Re: Design Exception #DE23-06 2261 Broadway, Meadowlark Gardens, Lot #6 –
Grade and Drive Isle Width

DESIGN EXCEPTION #DE 23-06

RE: 2261 Broadway, Meadowlark Gardens Lot #6 - Parking lot Grade & Drive
Isle Width

DE#23-06 2261 Broadway, Meadowlark Gardens Lot #6. – Parking lot Grade & Drive Isle Width

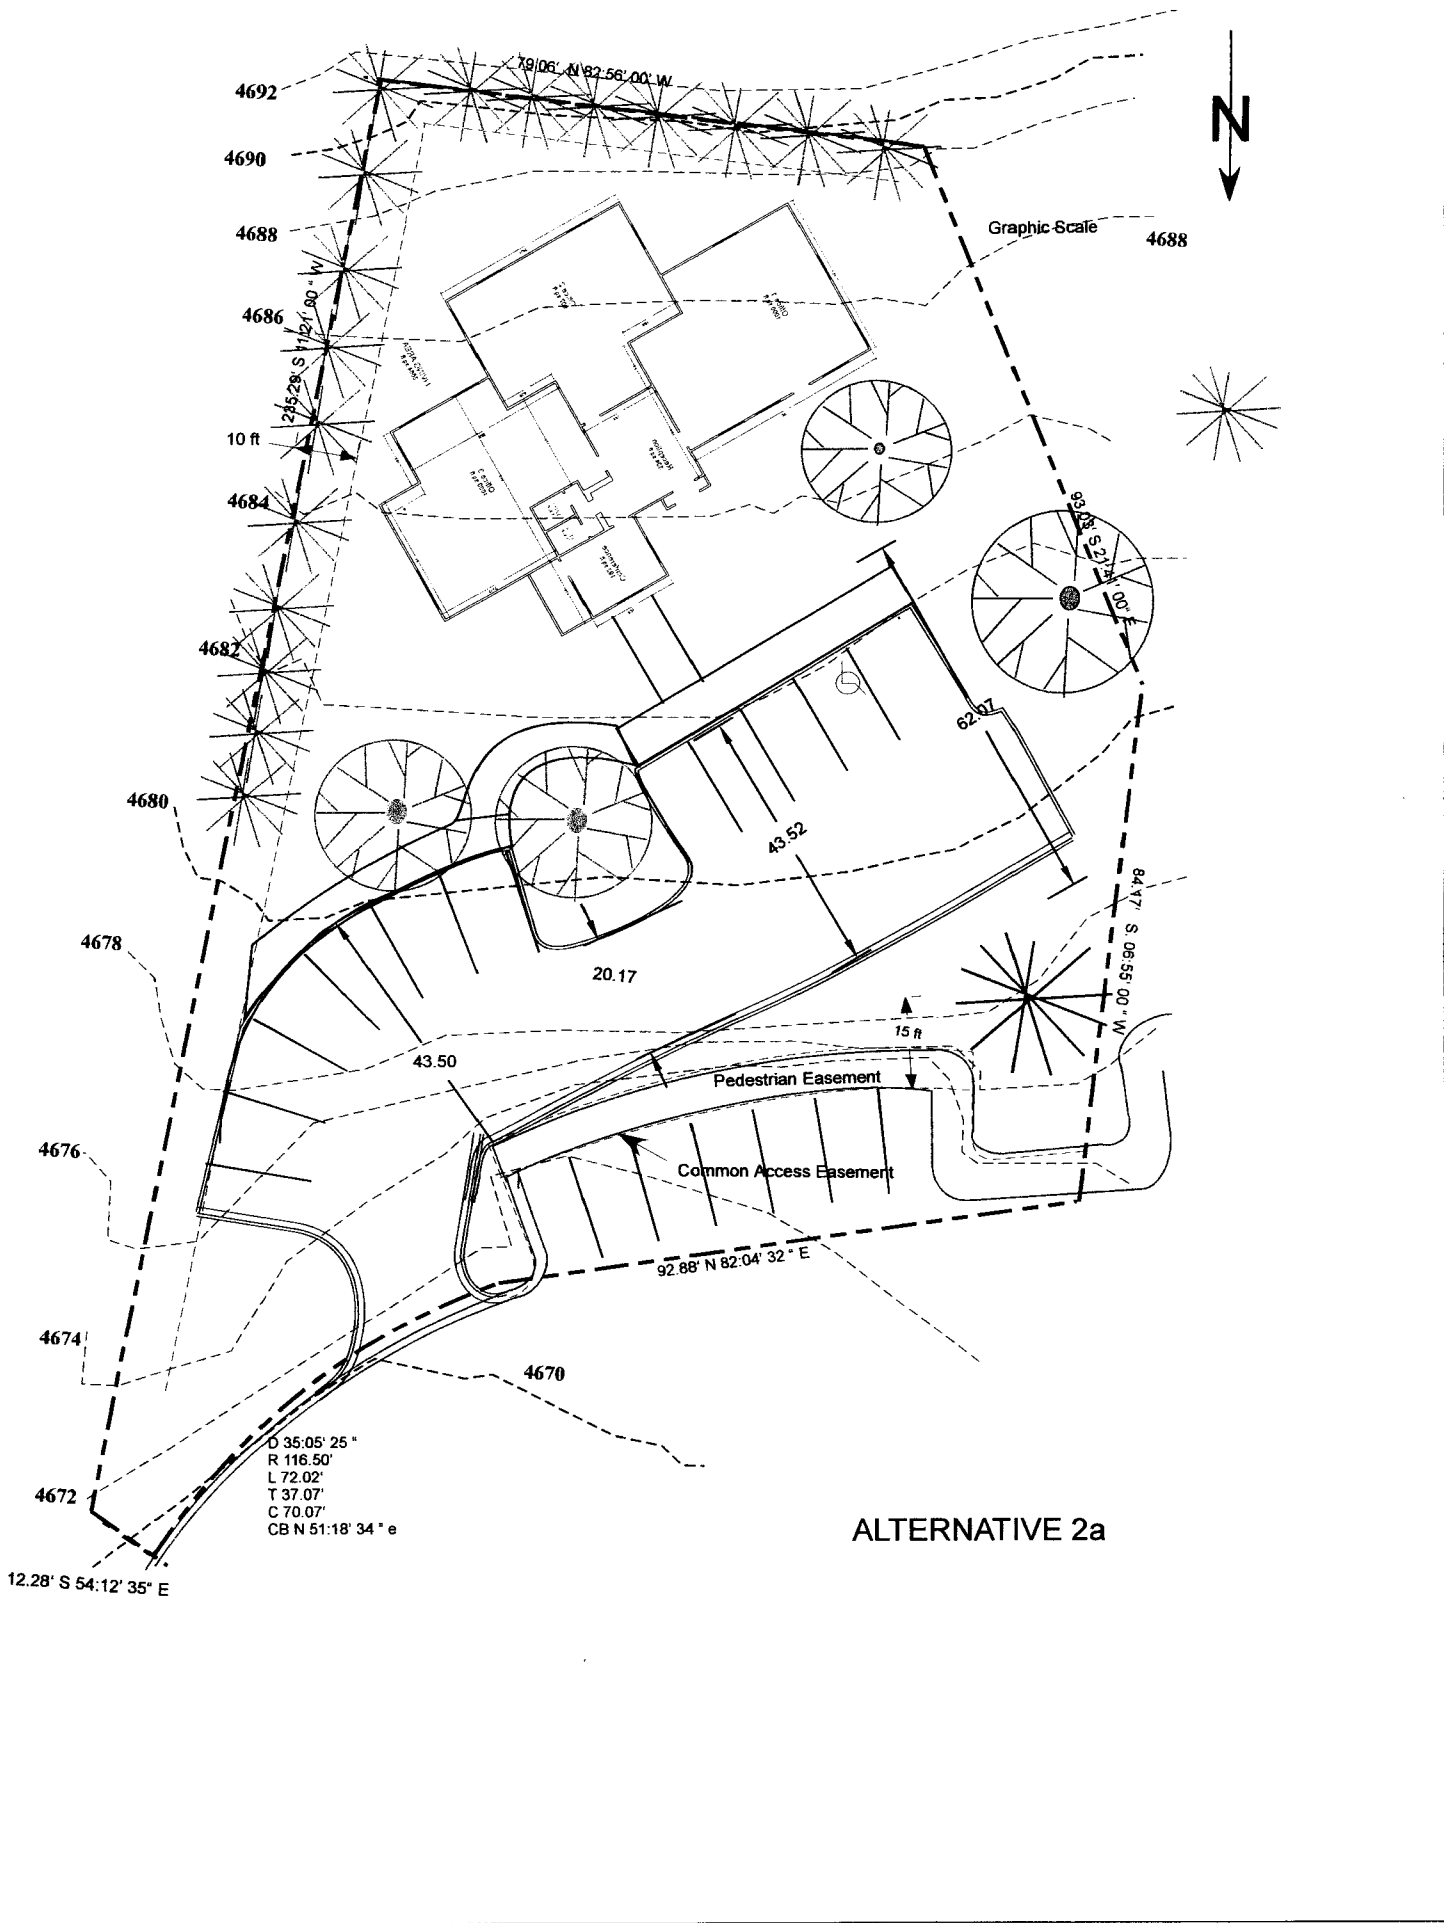
We would like to request an exemption to the TED's manual standard of a **maximum 8% grade permitted in parking lots** to allow a driveway proposed between two parking areas to be at a 12% grade for a distance of 25 feet. **In addition we request that this driveway be 16 feet in width.**

- Requested Exemption from TEDs Manual Requirements
1. Maximum parking lot slope 8% to permit 12% slope on driveway to address site slope and to reduce slope of parking spaces.
 2. Minimum driveway width of 20' to permit 16' width as shown to preserve existing trees.

Staff recommends approval of the exception as proposed.

ALTERNATIVE 2a

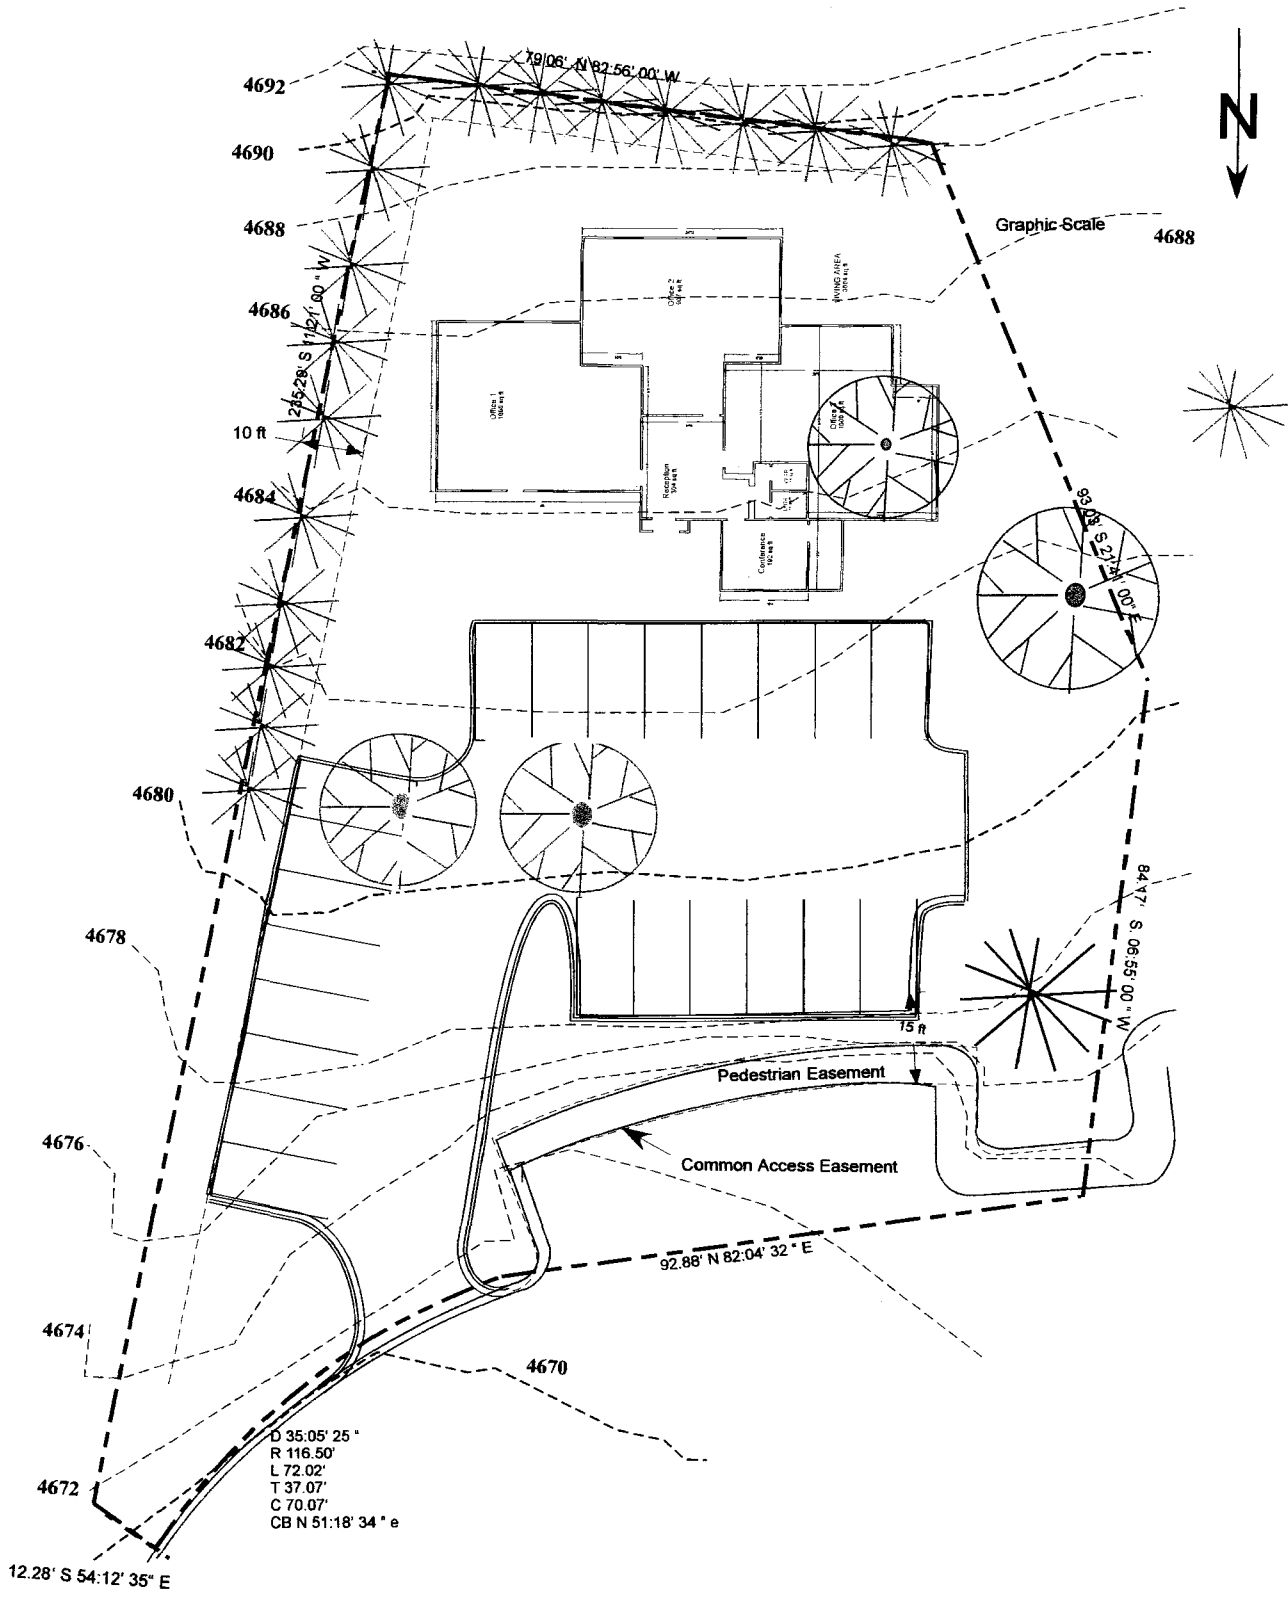
Alternative 2a

1. Only 12 parking spaces are possible compared to 29 in the proposed plan reducing the size of the building supported to 3600 sf of office or 2400 sf or retail compared to the 7200 sf of mixed retail and office in the proposed plan.
2. Most of the Parking is less convenient to the building.
3. The building is far from the main driveway and this layout does not conform well to the character of the development.

ALTERNATIVE 2b

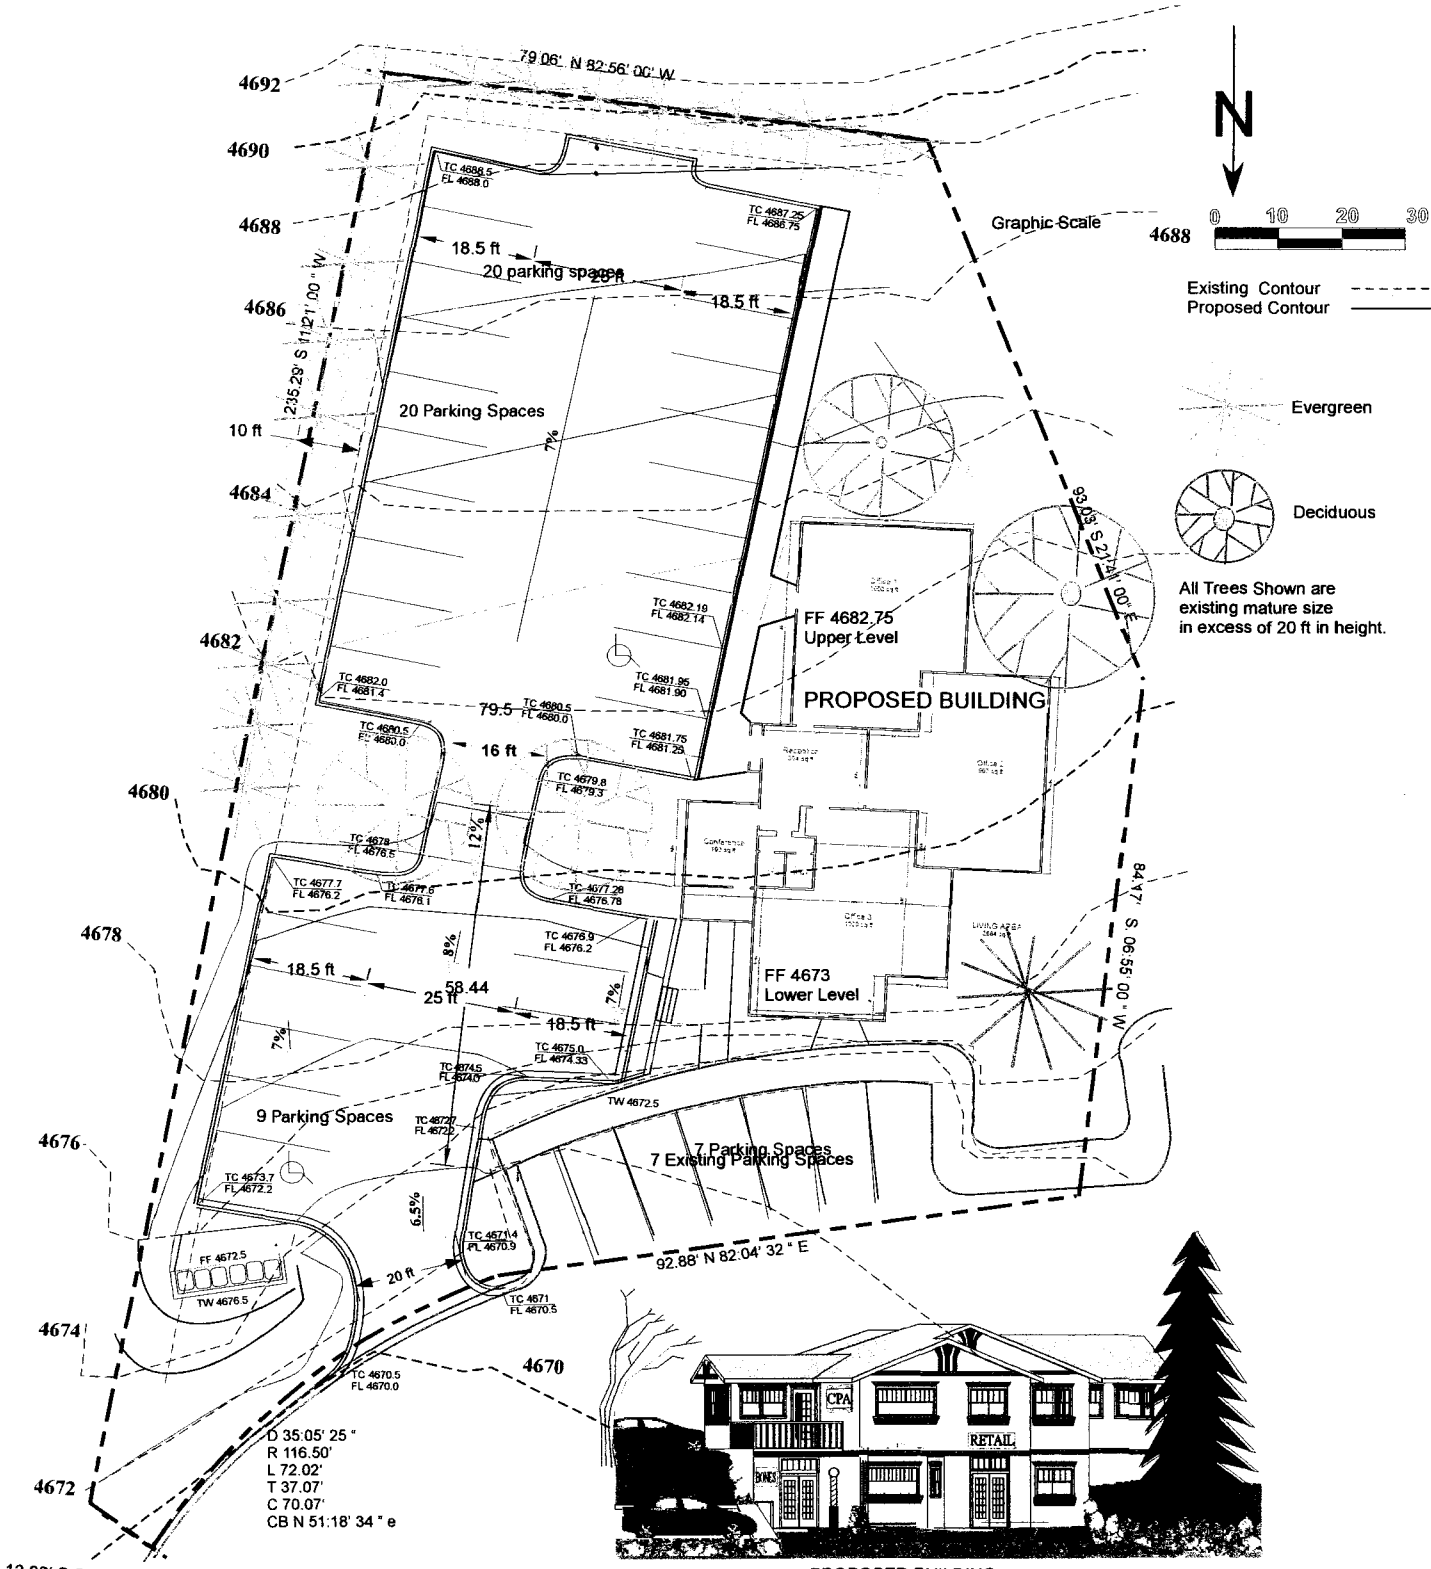
Alternative 2b

1. This layout eliminates three mature trees.
2. The parking is all at one level. No handicap parking or access is provided to the upper level of the building. The upper level of the building can only be accessed by stairs making it much less convenient and less desirable as commercial space.
3. The building would be set back from the main driveway by three bays of parking, which would be a very different character than that established through out the development. The visual impact on the entrance of the development would be parking and retaining walls. This is the opposite of the character described in the design guidelines of the development and probably would not be acceptable to the Property Owners Association.

4. 22 parking spaces are possible compared to 29 with the proposed plan reducing the size of the building by 1700 sf. However, the second floor level would be less desirable.
5. Access for emergency services would be less convenient.
